Village of Grantsburg

Village Board Meeting Agenda Monday, February 9, 2026 at 4:00 p.m. Village Board Room, 316 S. Brad Street

RE: Change Order 01
Village of Grantsburg
Grantsburg WWTP Improvements
SEH No. 184139 71.50

Change Order No. 1 to the Grantsburg WWTP Improvements project is enclosed. This Change Order includes six (6) items previously approved as individual line items by the Village Board and two (2) items that have not been approved. SEH recommends approval of Change Order No. 1 to incorporate the following changes into the Contract with Market & Johnson, Inc. (Contractor):

Building a Better World
for All of Us®

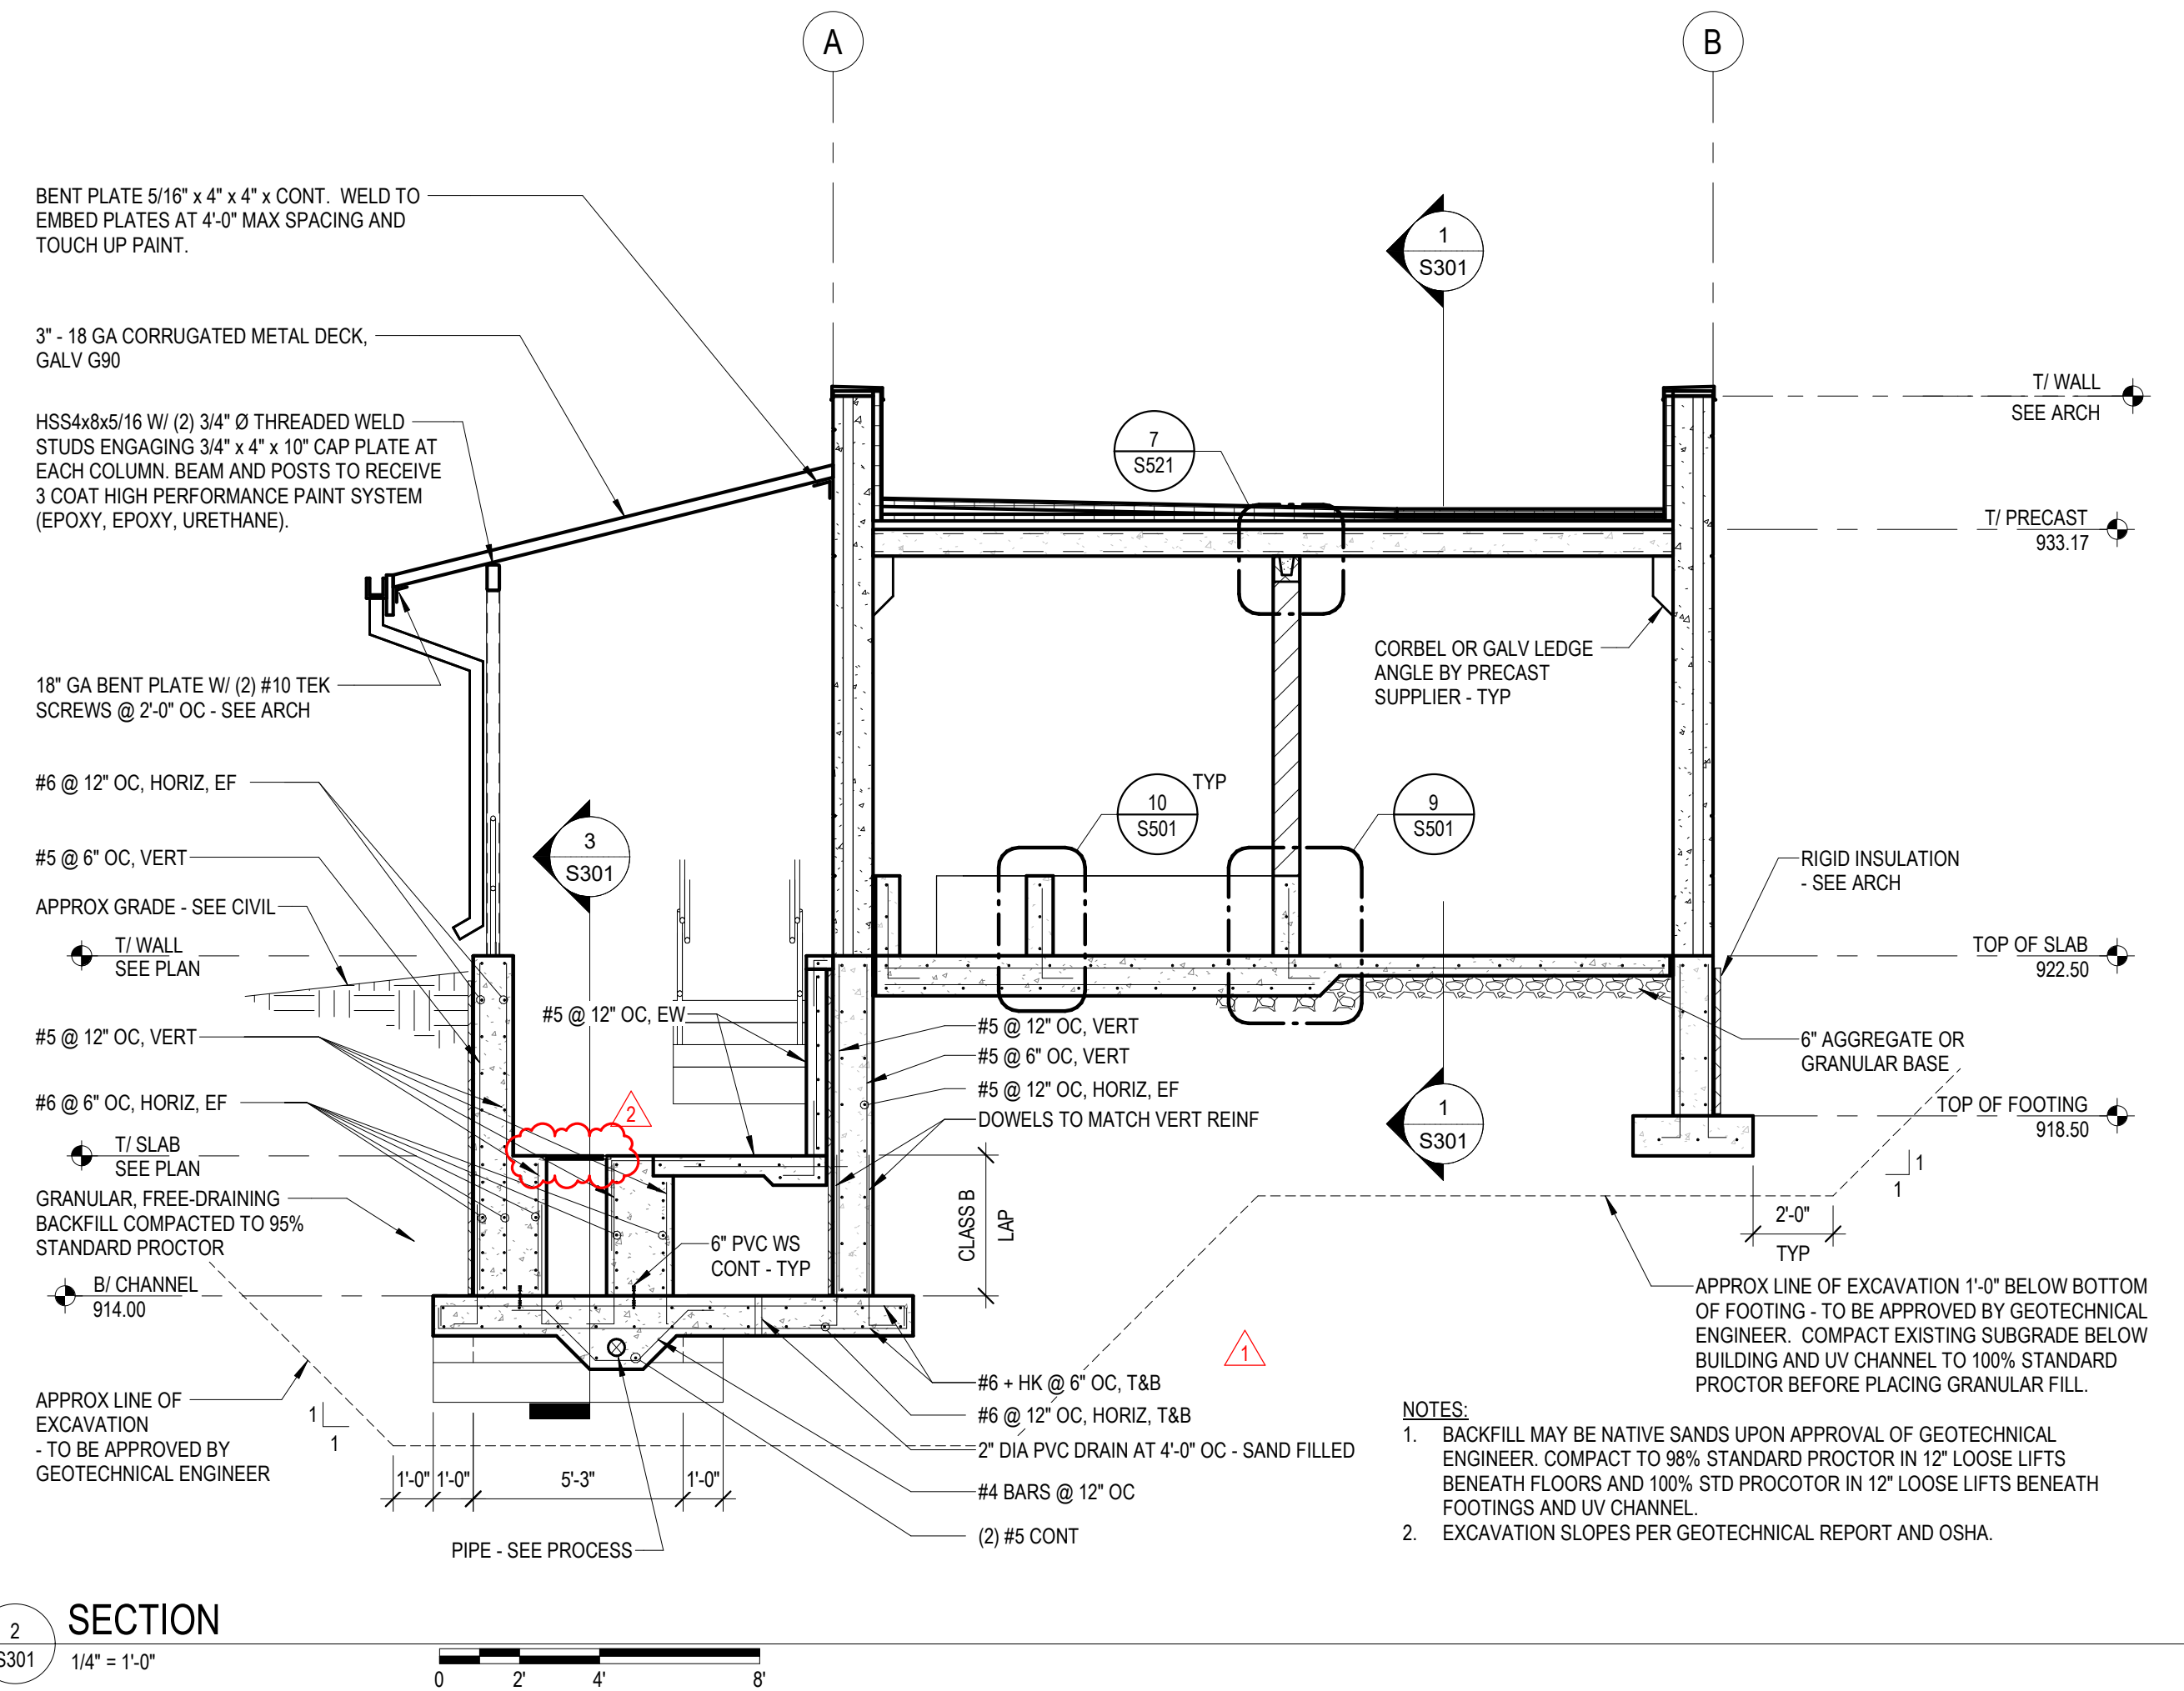
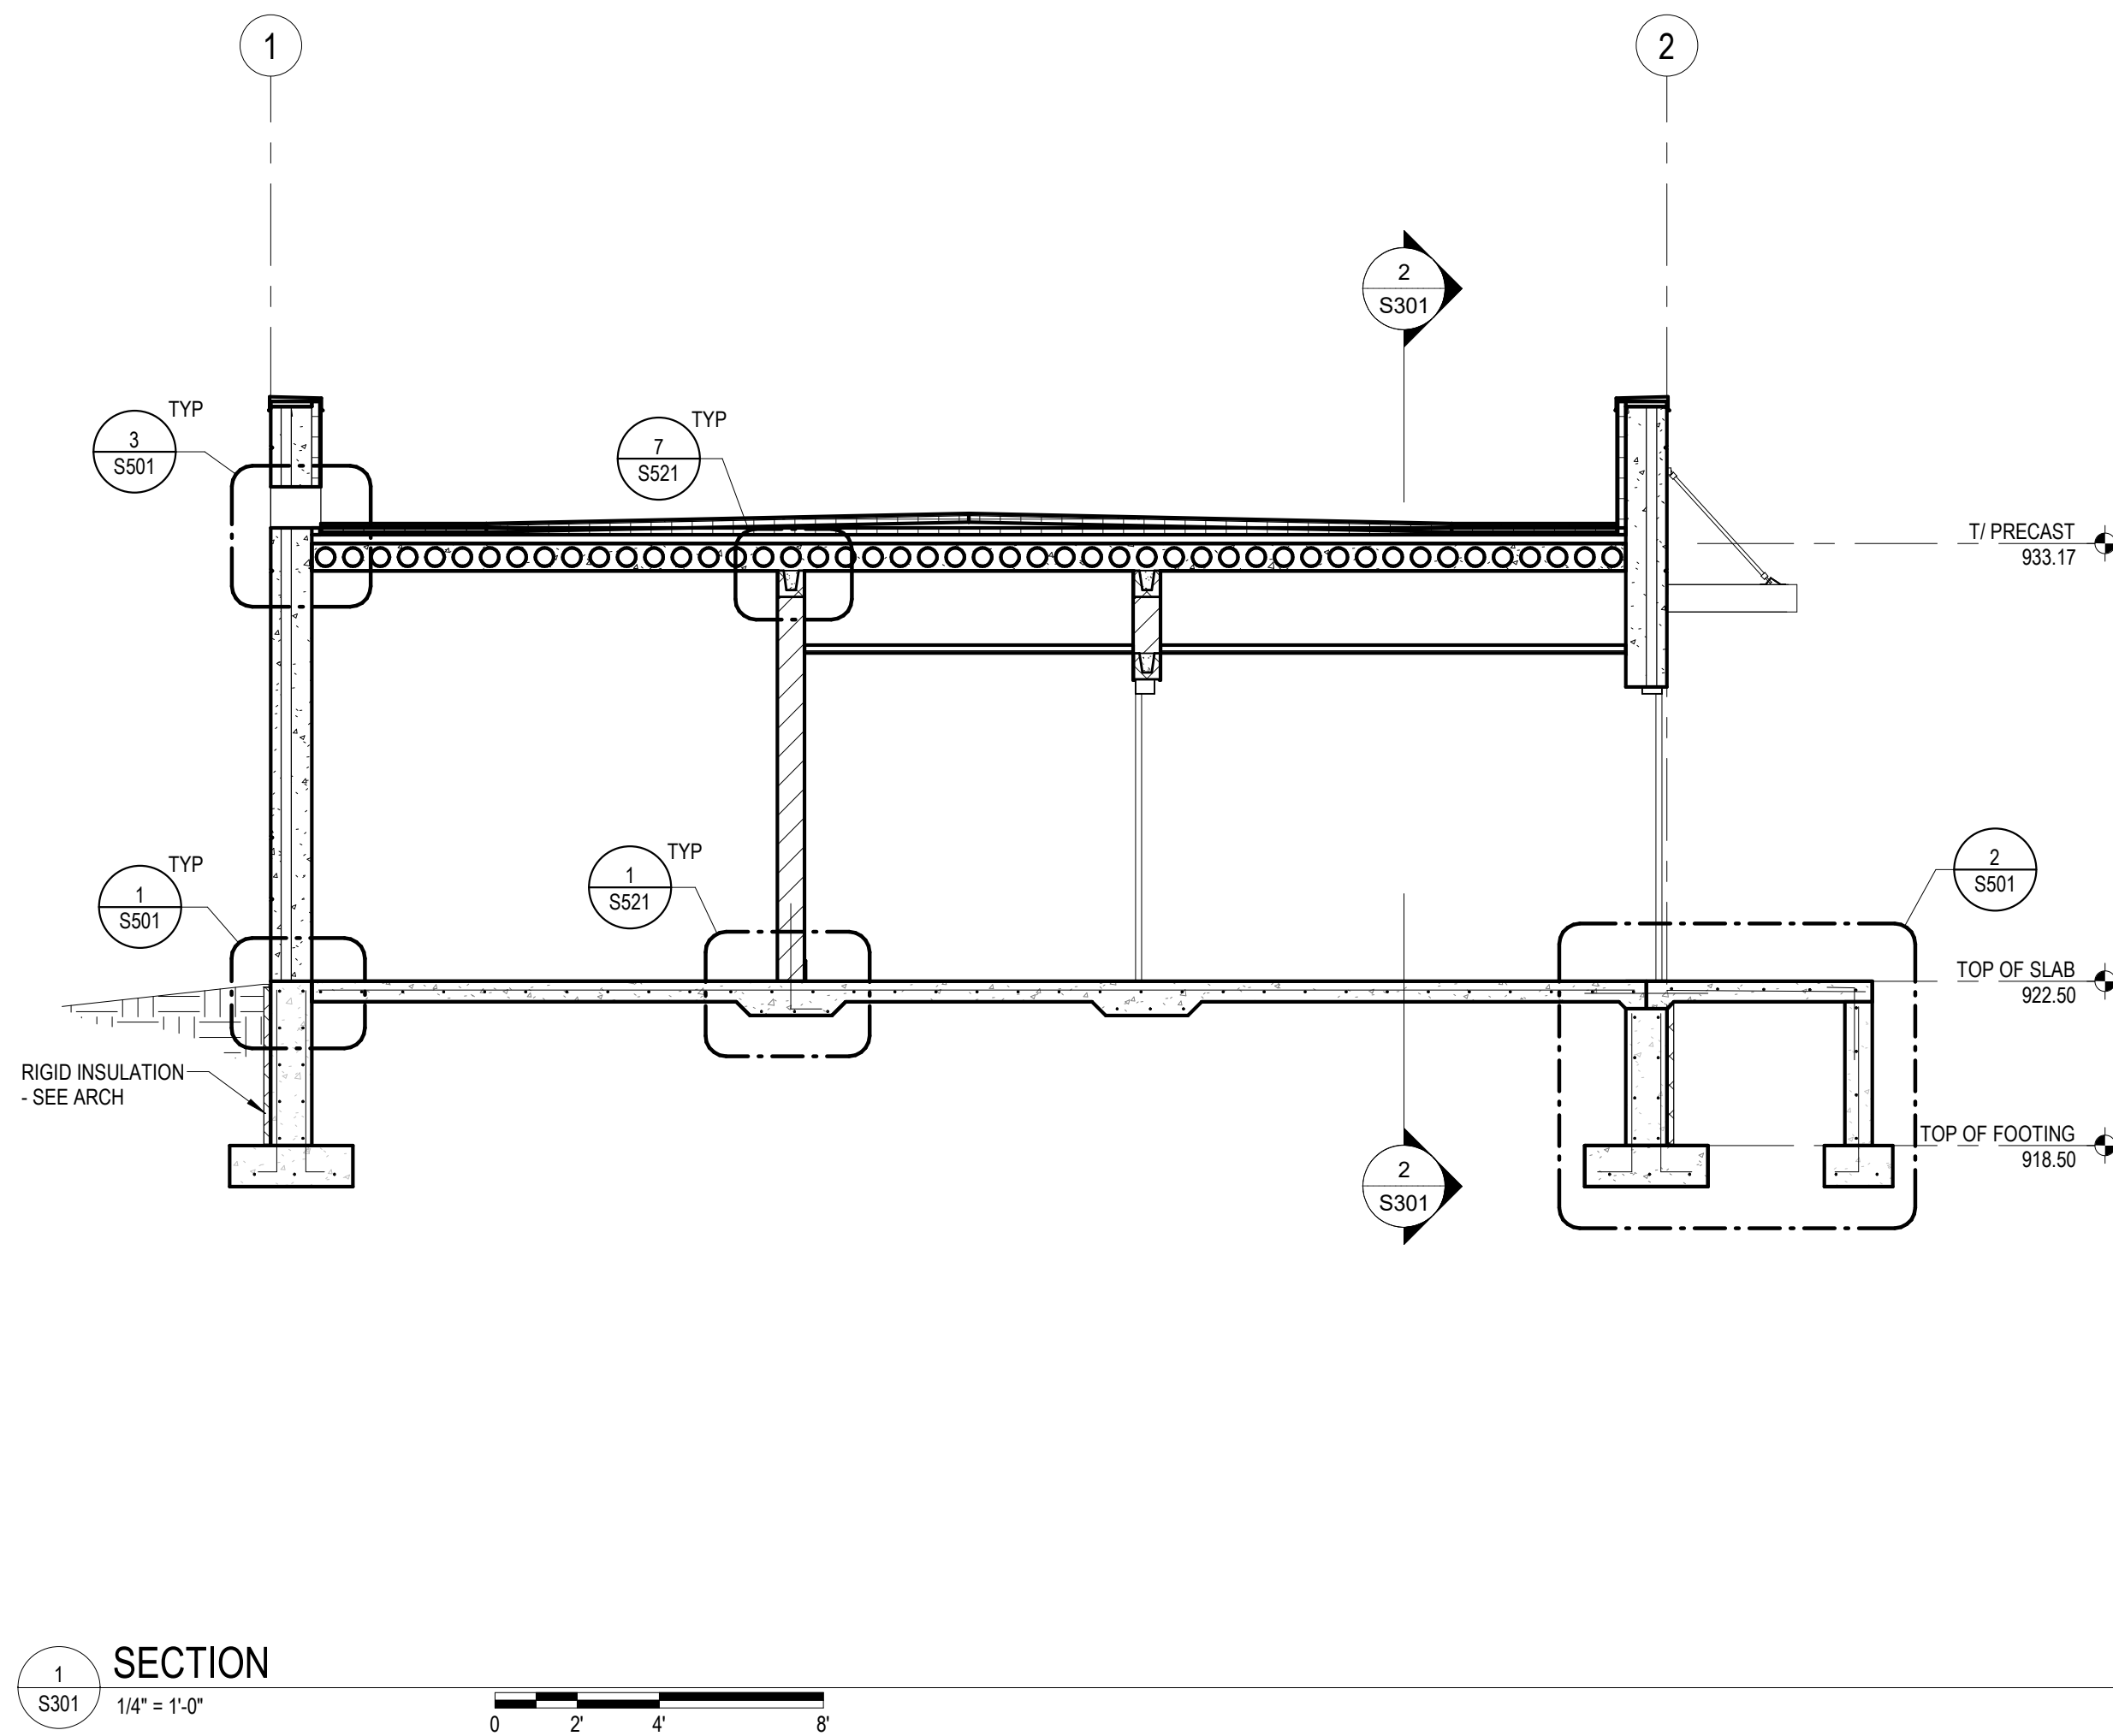
- Change Order Request #06 – UV Channel FRP Grating Modifications (FO #4)**
 Additional FRP grating materials are required to align with the UV equipment mounting details and to cover grating areas that were not fully defined in the original contract documents. The change amount of \$2,112.86 is recommended for approval, with no change to Contract Time. This change was approved by the Grantsburg Village Board on December 8, 2025.

We will go ahead and ask drafting to add these grating areas and embeds to the drawings.

- 1" FRP GRATING. GRATING DESIGN AND CONNECTION BY SUPPLIER'S ENGINEER. COORDINATE EXTENTS WITH PROCESS DRAWINGS AND APPROVED UV EQUIPMENT SUBMITTALS - SEE DETAIL 3/S531.

- 1 1/2" FRP GRATING. GRATING DESIGN AND CONNECTION BY SUPPLIER'S ENGINEER. COORDINATE EXTENTS WITH PROCESS DRAWINGS AND APPROVED UV EQUIPMENT SUBMITTALS. SEE DETAIL 3/S531 (TYP.) & 4/S531 WHERE WALLS CONTINUE UP (LEDGE IN CONCRETE NOT VIABLE).
